FINAL
NAVAL AIR STATION ALAMEDA RESTORATION ADVISORY BOARD
MEETING SUMMARY

November 2, 2006

ATTACHMENT B-3
PRESENTATION ON IR SITE 2 DRAFT FS
(14 Pages)

TAPP GRANT PRELIMINARY REVIEW ON PROPOSED PLAN FOR IR SITE 1

Site 1

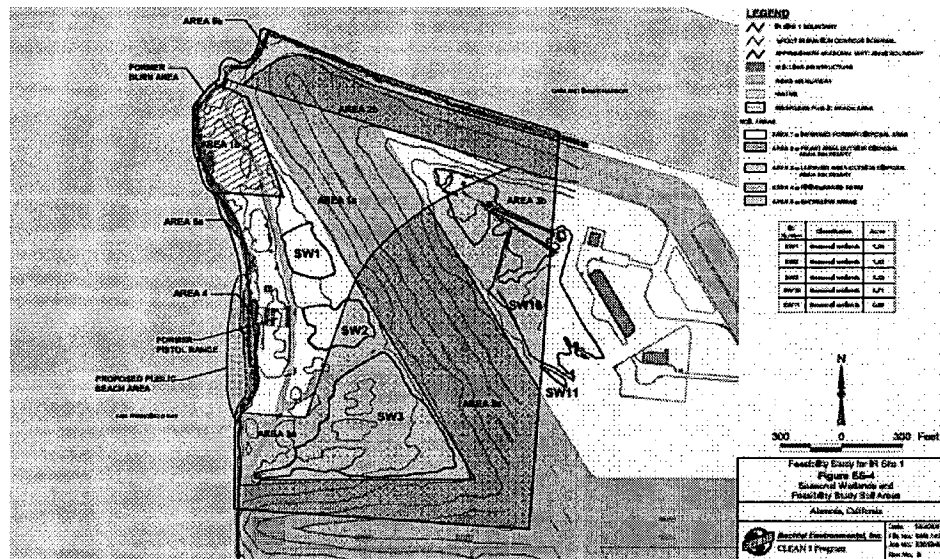
Slide 3 showed a map of the site that was used in the PP; Mr. Strauss claimed that this map is confusing and hard to read. Mr. Strauss recommended converting this PP to an interim PP. He agrees with actions in the PP including excavation and removal of the burn area, removal of all radium-contaminated wastes from Areas 3, 5, and 1b, and removal of the berm from the firing range.
